PRODUCT BULLETIN

Low Level Strainer Inlet

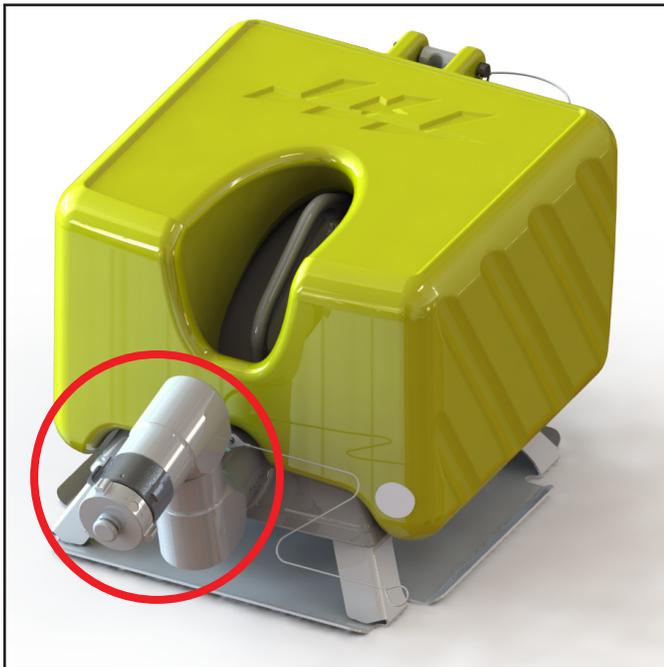
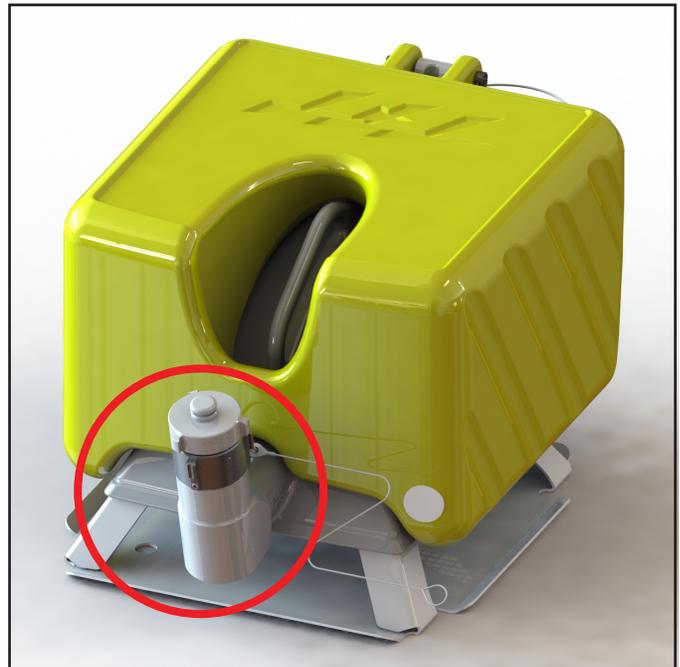
A design change has been made to the inlet configuration for all Low Level Strainers.

**PREVIOUS DESIGN
THROUGH 1/2022**

**UPDATED DESIGN
BEGINNING 2/2022**

Features and Benefits	
Fewer Moving Components	Less Cumbersome
	Easier to Make Connections
Smaller Overall Package	5.25" Length Reduction
	1.5 lb. Weight Reduction
